Addendum Addenda

No./No 2

Domestic Hot Water Conversion to Electric/Conversion du système d'eau chaude domestique en système électrique

dwg.no. 5909-G01 dessin no.

2 NEW DOMESTIC HOT WATER SUPPLY LAYOUT
MO1

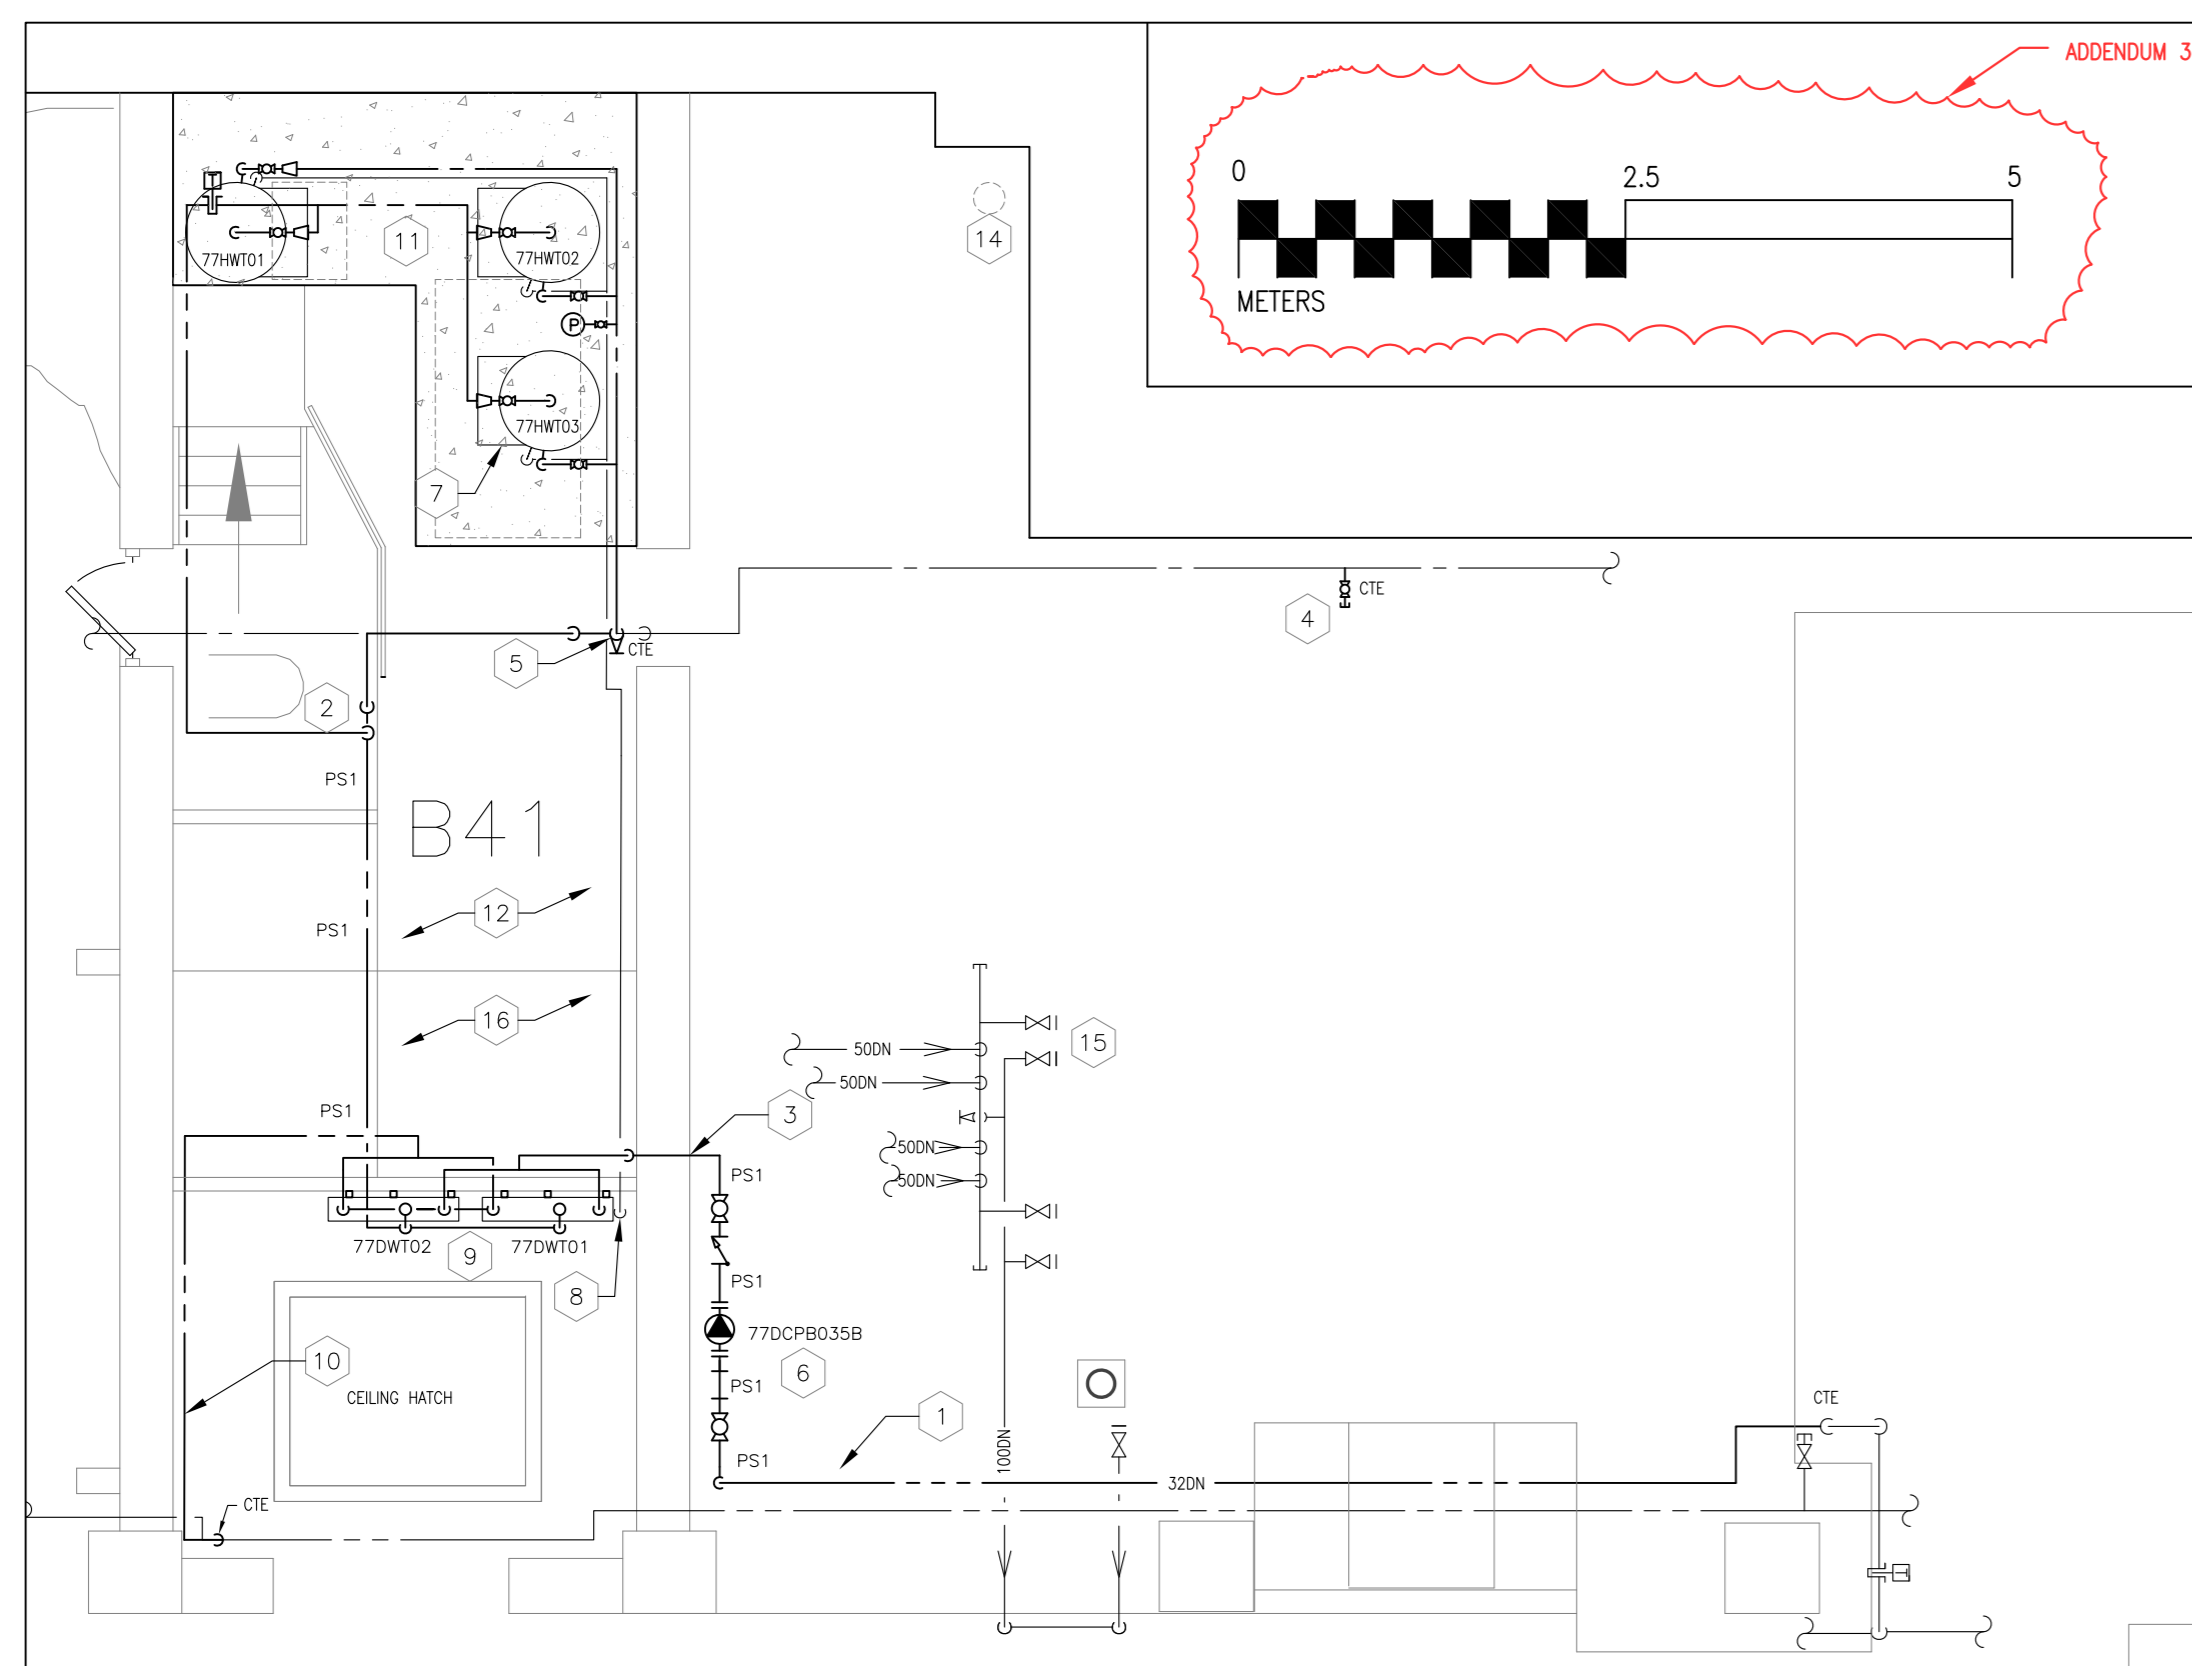
Item No	Description
1	G01 Detail 2 Note 16: Add: Paint concrete topping with new epoxy paint (Grey), 102mm strip at edge to be painted caution yellow.
2	Entire Room B41 to be Power Washed prior to Epoxy Paint application. This Contractor is required to protect all surfaces and services.
3	While performing any work within Mech Room 039, HEPA Vacuum is to be used at all times.
4	G01 Detail 2 note 14 Delete and replace with void to be filled with Rockwool and covered with fire rated self levelling silicone and provide 12mm thick steel plate to cover opening.
5	Exact location of all equipment to be coordinated on site with NRC department representative.
6	See attached job showing Attendance sheet.
7	Question: I noticed the drawing no. 5909-G01 has mechanical layout drawings but no scale. Do you have a scaled version for the demolition and construction to be done? Response: Replace drawing 5909-G01 with new 5909-G01 drawing issued in addendum 3.

- NEW CONCRETE INFILL TO LEVEL OF EXISTING CONCRETE PADS; APPROX. 102mm THICK 25 MPa C/W 15M DOWELS AT EACH CORNER AND AT 610mm O.C. EACH DIRECTION. DOWEL TO EXISTING ROUGHENED CONCRETE SURFACE. NEW CONCRETE TO RECEIVE 15M Ø305mm EACH WAY. PAD TO BE WOOD FLOAT FINISHED WITH CHAMFERED EDGE. EXACT LOCATION TO BE DETERMINED ONSITE. PAINT CONCRETE WITH NEW EPOXY PAINT (GREY), 102mm STRIP AT EDGE OF CONCRETE TO BE PAINTED CAUTION YELLOW.
